September 5, 2017

Re: Objection to Draft Decision (ROD) for Atlantic Coast Pipeline Project through the George Washington and Monongahela Forests

Map 1. Scenic Integrity Impacts of the ACP and Access Roads on the SMNSA and Wild Oak National Recreation Trail

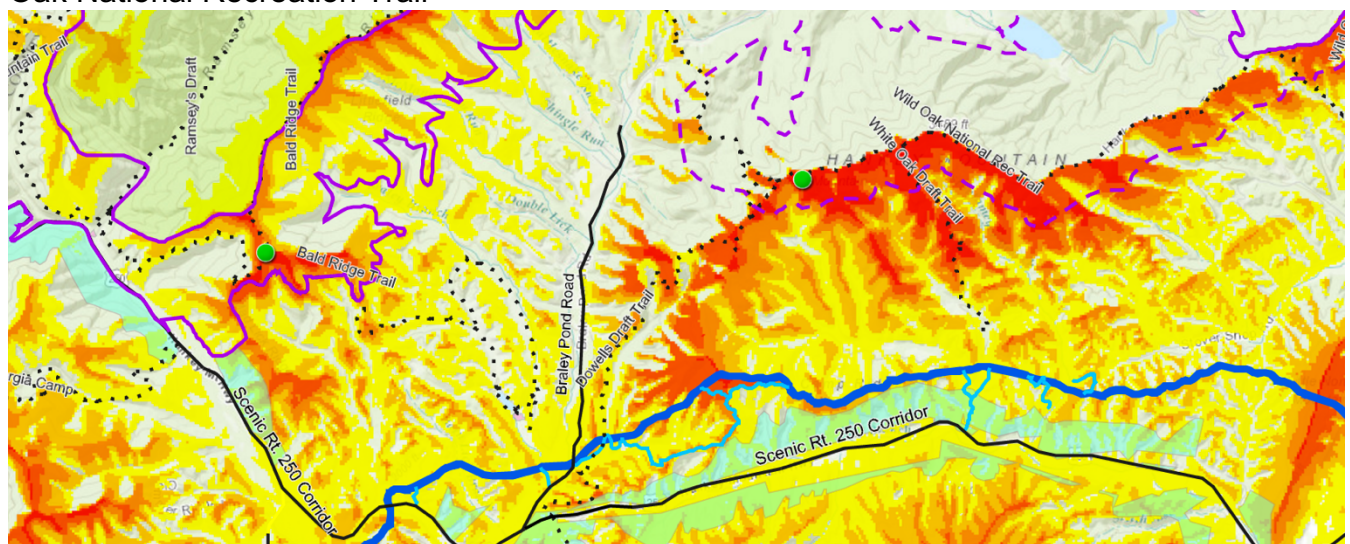
The EIS fails to adequately address scenic integrity impacts to the SMNSA. The pipeline crossing near the intersection of Rt. 250 and Rt. 715 (Braley Pond Rd) is a concern primarily because Rt. 250 is a major gateway to scenic and recreational resources on Shenandoah Mountain. Visitors form a first impression of the proposed SMNSA based on the visual experience from Rt. 250. A 125- to 175-foot wide construction corridor and 55-foot permanently-cleared corridor will significantly degrade the scenic quality of the southern end of the SMNSA.

According to the GWNF Plan, Rt. 250 is a "Scenic Corridor" (turquoise on Map 1) and GWNF land along this corridor will be managed to protect scenic values: "High quality scenery is provided in sensitive recreational and travelway settings.... The area visible during leaf-off for up to one-half mile from either side of the road typically defines the corridor... These areas are unsuitable for designation of new utility corridors, utility rights-of-way, or communication sites... The emphasis is on providing high quality scenery in sensitive recreational and travelway settings." While the ACP route skirts the Rt. 250 Scenic Corridor management prescription, it is located squarely between the Scenic Corridor and the proposed SMNSA.

The Draft ROD states that the impacts will not meet the GWNF Plan's "moderate" Scenic Integrity Objectives for the Hankey Mountain area. The EIS dismisses long-term visual effects. The ACP route would be clearly visible from several popular trails in the proposed Shenandoah Mountain National Scenic Area, including the Wild Oak National Recreation Trail on Hankey Mountain (green dot on right on Map 1) and Bald Ridge Trail in Ramseys Draft Wilderness (green dot on left on Map 1). It would also degrade the scenic quality of the Rt. 250 gateway to the following recreational resources:

Map 3: Rt. 250 is a primary access to recreational sites and trails within or just outside of the SMNSA

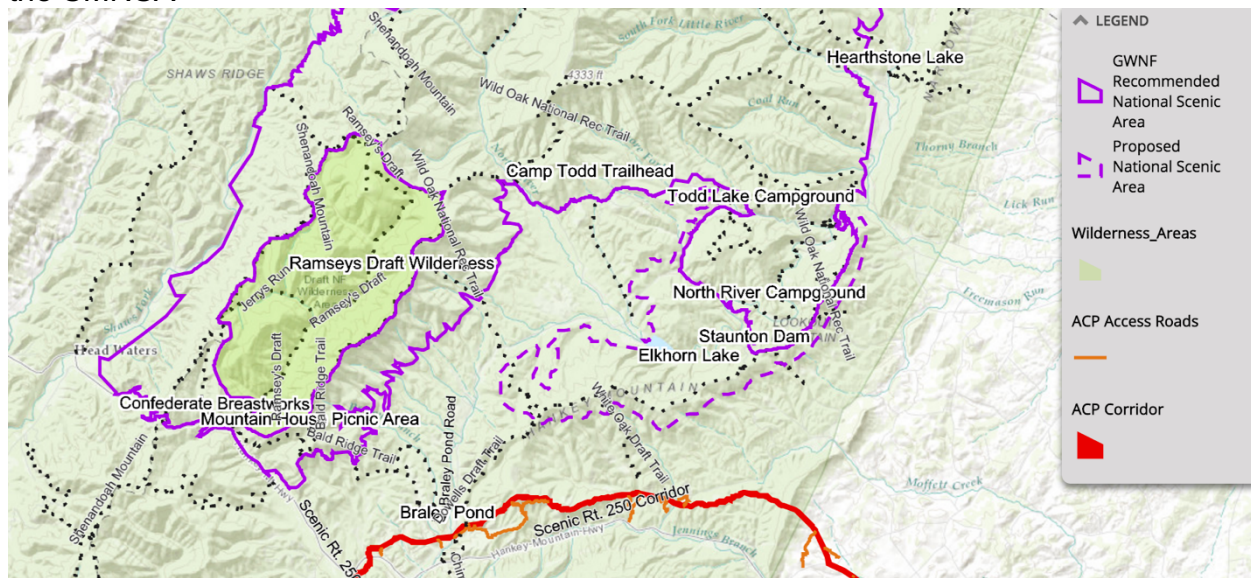
The scenic Rt. 250 gateway is perhaps the most heavily used access to prime recreational resources located in or adjacent to the proposed Shenandoah Mountain National Scenic area (shown on Map 3):

The EIS for the ACP project does not discuss or evaluate these potential impacts, and the Draft ROD ignores these important impacts.
